# BICESTERBUG

## **Submissions on proposed housing in NW Bicester**

**21/01630/OUT**

**22 June 2021**

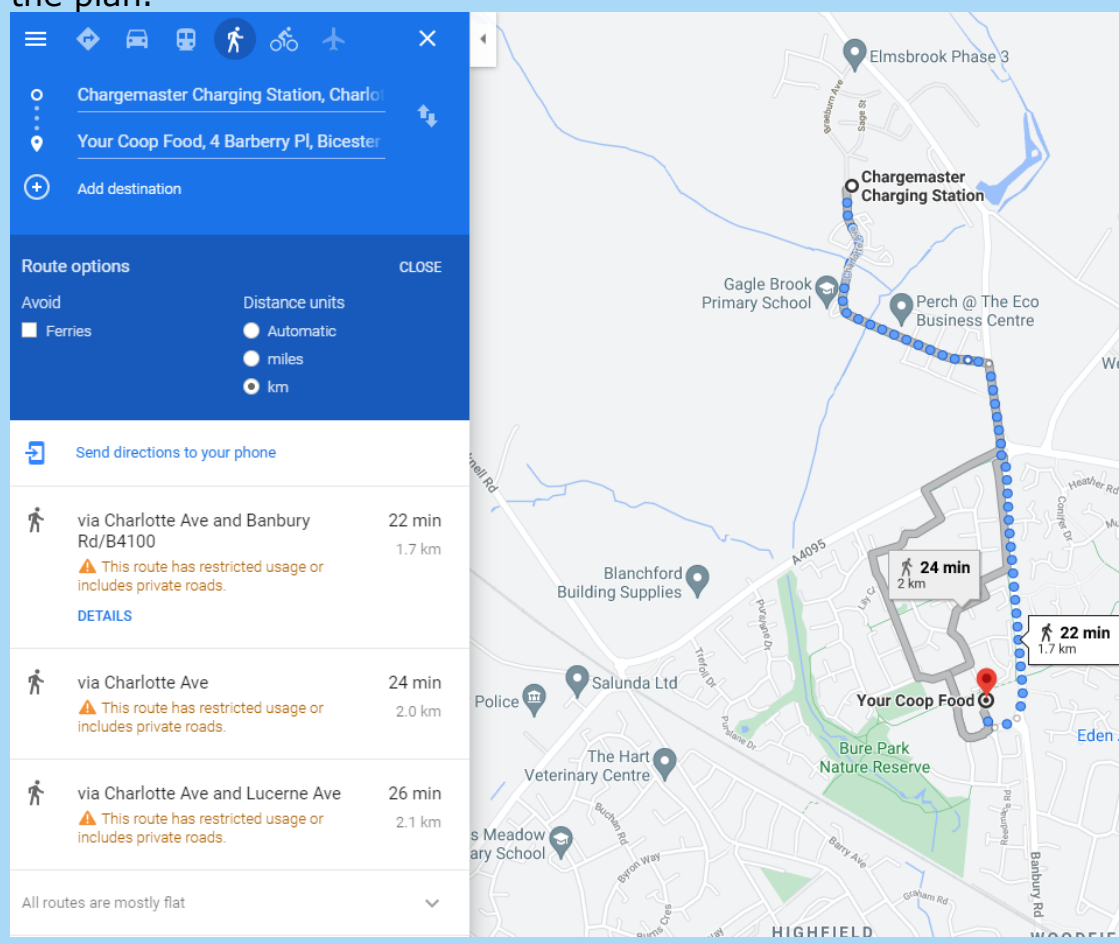
Table 4.2 in Appendix 6.2 of the application contains incorrect (lower than reality) walking distances to local amenities. For example the walking distance to Jardines Pharmacy and Coop is 1.7km not 1km as indicated (see googlemap screenshot below). This undermines the diligence of the travel planning for active travel and the credibility of the plan.

Figure 1: Aunt Em's Lane Connection (taken from Fig 5.3 of Appendix 6.2)

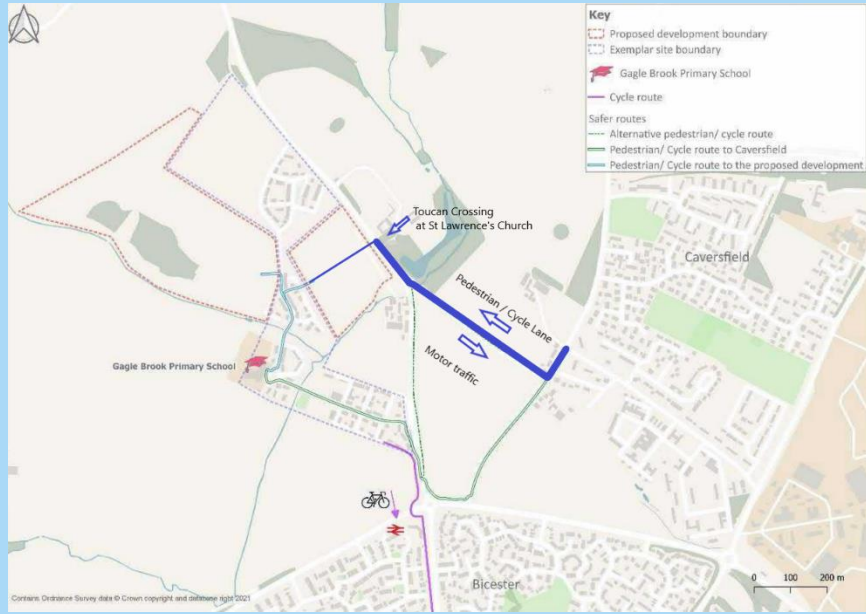
In order to connect to neighbouring communities, active travel links to the site via Aunt Ems Lane (the lane between the B4100 and the Fringford Road) should be included in the plans. BicesterBUG rejects the notion that the Fringford road offers a suitable route, as outlined above. We reiterate that one low cost possibility would be to provide a dedicated active travel corridor between NW Bicester and Caversfield by closing Aunt Ems Lane to motor vehicle traffic. We note that the developer has assessed the connection (in ES vol 2 Appendix 6.1 and 6.2 Transport assessment), we disagree with the assessment and contend that with minor changes suitable active travel provision can be constructed. The reasoning that the existing route via skimmingdish lane is shorter than an alternative via Aunt Em's lane and the east development parcel (e.g. via Home Farm) is not proven

Alternatively, Aunt Ems Lane could be made one-way for motor traffic from the B4100 to the Fringford Road to maintain access, allowing the current E-Bound lane to be segregated into a bi-directional active travel route. This option would provide safe access between the proposed development, Caversfield, the church and the school. The addition of a path along the eastern side of the B4100 from aunt em's lane to St Lawrence Church and a crossing to the proposed development site would make a valuable addition to the active travel connectivity of the development and the wider area. This would unlock active travel access to the church which is currently not possible from Elmsbrook or Caversfield.
